Advanced Reactor Stakeholder and Construction Permit Guidance Public Meeting

February 25, 2021
Microsoft Teams Meeting
Bridgeline: 301-576-2978
Conference ID: # 157 353 886

Industry Construction Permit Guidance Task Force initial observations and feedback on NRC Draft CP Guidance

U.S. Nuclear Industry Council Comments for NRC Stakeholders meeting: Construction Permit Guidance

Figure 1. Evolution of the PRA as the Plant is Designed, Constructed, and Operated
 (Excerpt from NRC Staff Draft White Paper: Demonstrating the Acceptability of Probabilistic Risk Assessment Results Used to Support Advanced Non-Light Water Reactor Plant Licensing)

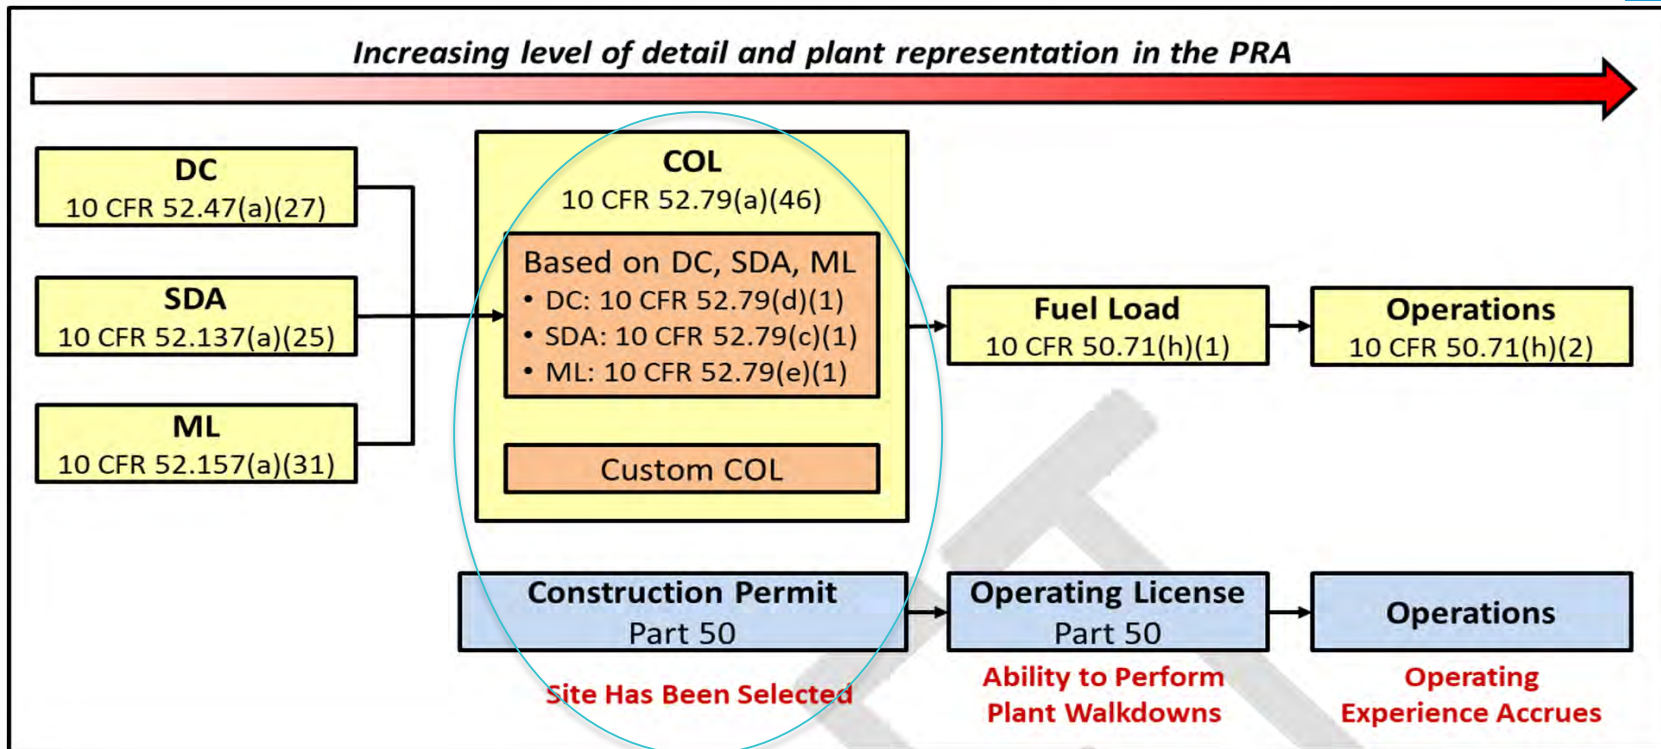
- *The Policy Statement on “Severe Reactor Accidents Regarding Future Designs and Existing Plants” does not specify when a PRA needs to be complete and what level of completion is required.*
- *The “Pedigree of PRA” for a CP application as specified is not realistic. It is not reasonable to require that a peer review be performed at the CP stage.*
- *The description of the PRA methodology is not needed in the application as it is reviewed for acceptability during the peer review. The PRA methodology documents are available for NRC audit.*
- *NRC seems to specify that the PRA requirements for a CP are the same as for a COL.*

CP application stage: The site has been selected; the PRA represents the conceptual design.

PRA that support custom COL or CP applications: A full-scope peer review should be conducted.

Construction Permit – Discussion of Completeness and Maturity

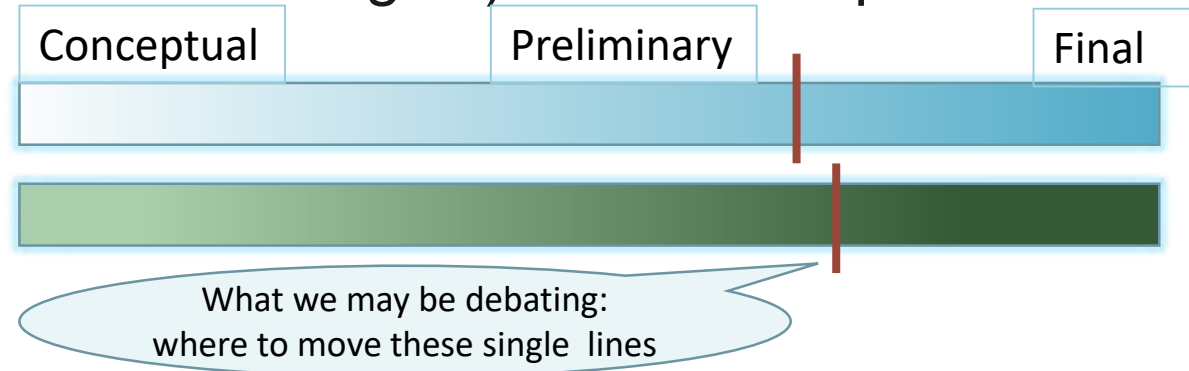
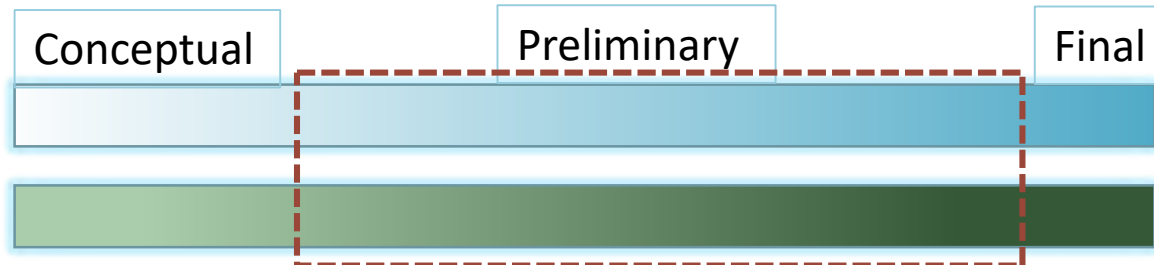
Image shows conceptual thinking to discuss how compliance will be assessed (i.e. “What size box of possible information (which will vary in completeness and maturity for different advanced reactor technologies) will be acceptable for CP?”)

What we desire: this spectrum of
completeness/maturity could all be acceptable
